- STAFF REPORT -

DR 96-02

I. APPLICANT'S REQUEST:

The applicant is requesting site and design approval to construct a 6,155 square foot single-story professional office building. The development is proposed to occur on an 16,100 square foot parcel.

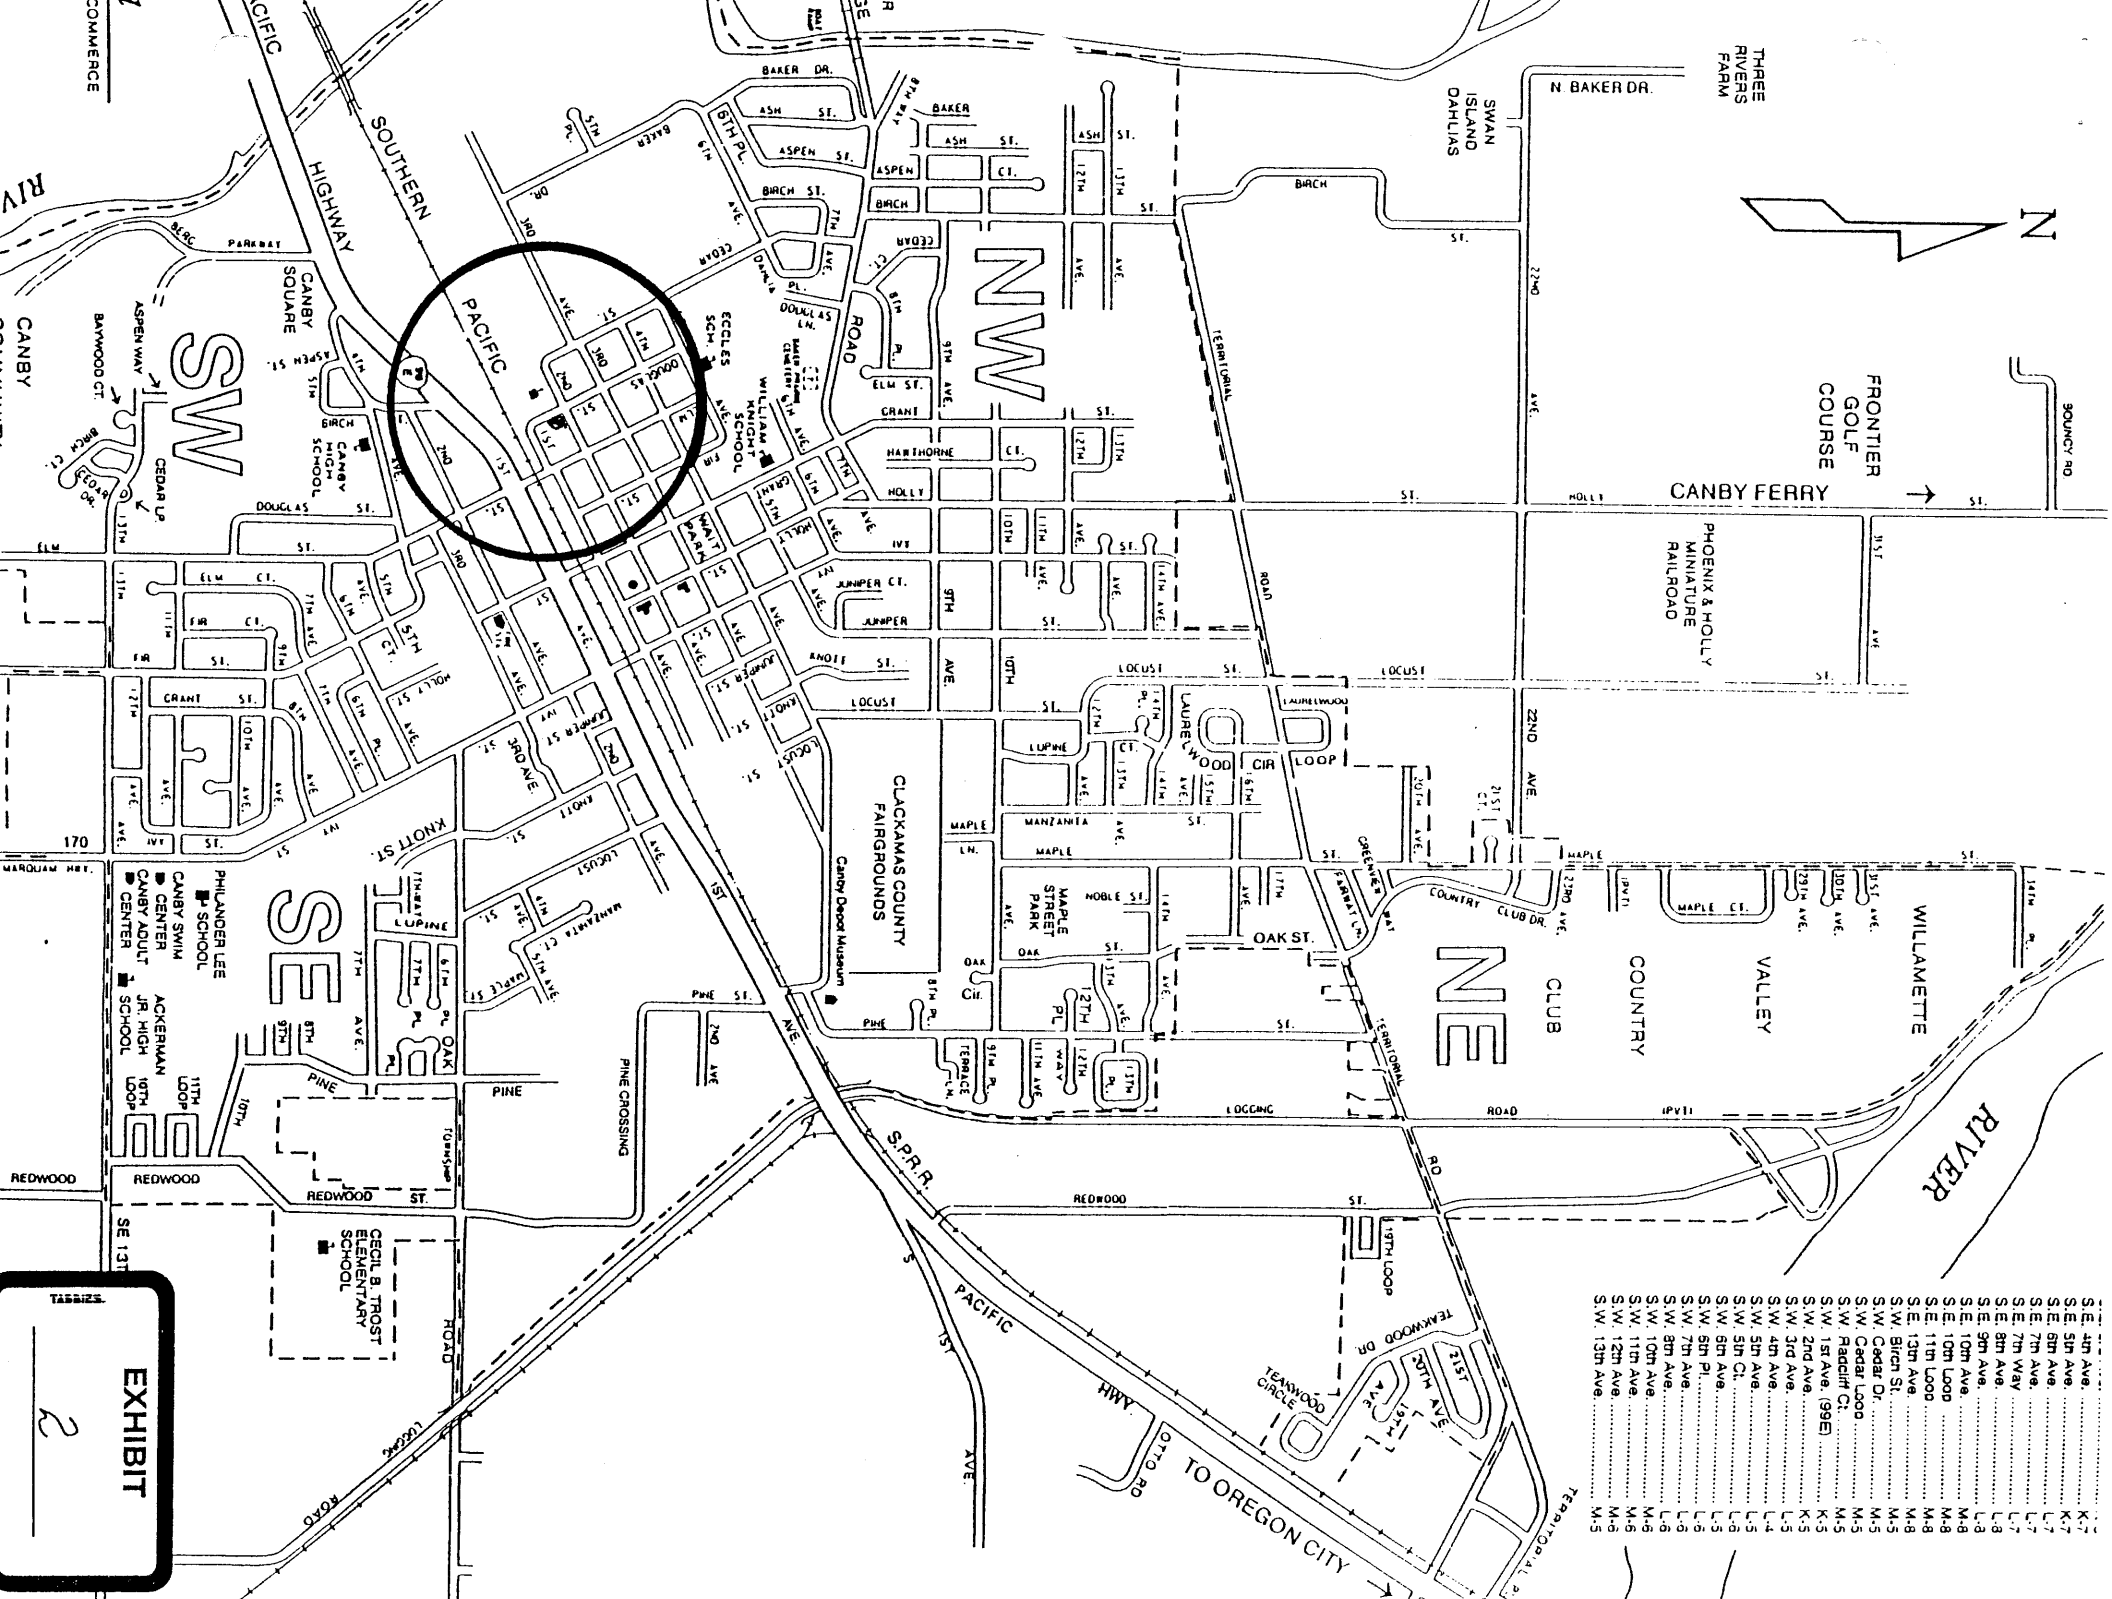
The minimum amount of landscaping required for the 16,100 square foot parcel is 2,415 square feet (15%). Because there is extra right-of-way that will not be needed for sidewalk or street improvements, the landscaping of this area will be credited toward the required amount. The total developed area of the site then becomes 20,569 square feet, which requires 3,085 square feet of landscaping (15%). The total amount of landscaping proposed is approximately 4,490 square feet (21.8%).

The number of parking spaces required for a professional office use such as is proposed is 22. There are 33 parking spaces being proposed, including 1 ADA (American Disabilities Act) parking space (1 required), and 5 compact parking spaces (A maximum of 7 permitted). The ADA parking space is "van accessible" (1 required).

No loading areas have been proposed. One is required. No arguments have been provided or why a loading area is not proposed. The design of the building is such that there will be two separate office areas, each less than 5,000 square feet. In this situation, each of the commercial uses would have less than 5,000 square feet and an argument could be made that loading areas/facilities would not be required. However, eventually, one business could occupy the whole building (6,155 square feet), thus necessitating a loading area/facility. The Planning Commission will need to decide whether or not a loading area will need to be provided.

Wheel stops are normally required for all the parking spaces that front either a walkway or landscaping. The walkway is proposed to be seven (7) feet wide, which will allow for a two (2) foot overhang and still provide a five (5) foot walkway for pedestrian use. The arborvitae proposed for the eastern property line, will need to be planted at least three (3) feet away from the parking spaces to allow cars to utilize the two (2) foot overhang without damaging the plants. Groundcover will be planted between the arborvitae and the parking spaces.

The parking area will be accessed from both N.W. 2nd Avenue and from the alley along the southern property line. The alley will need to be paved to a width of eighteen (18) feet, along the property's frontage of the alley. The layout of the parking and the building allow the building to be located on the corner of N.W. 2nd Avenue and N. Douglas Street, with the parking lot located behind the building. This layout tends to be more aesthetically pleasing and more pedestrian friendly. The access drives are twenty-four (24) feet wide.

The building will have a brick veneer exterior with a metal roof. The roof will vary between a sloped center and flat exteriors with a vertical metal screening around the mechanical equipment. No colors were proposed in the application file.

3. A detailed landscape construction plan shall be submitted with the building permit. The detailed landscape plan shall show: the number of plants, plant spacing/location of planting, the type of plants, the size of plants, the schedule of planting, and irrigation plans.

5. A storm system with catch basins shall be installed along N. Douglas Street. A storm water drainage plan shall be submitted with the building permit application.

6. The alley shall be paved to a width of eighteen (18) feet along the property's full frontage of the alley.
7. The arborvitae to be planted along the eastern property line shall be planted a minimum of three (3) feet from the curb along the parking spaces.

8. The walkway between the parking spaces and the building shall not be less than seven (7) feet in width. The A.D.A. parking space shall be designated as such with the appropriate and required signage.
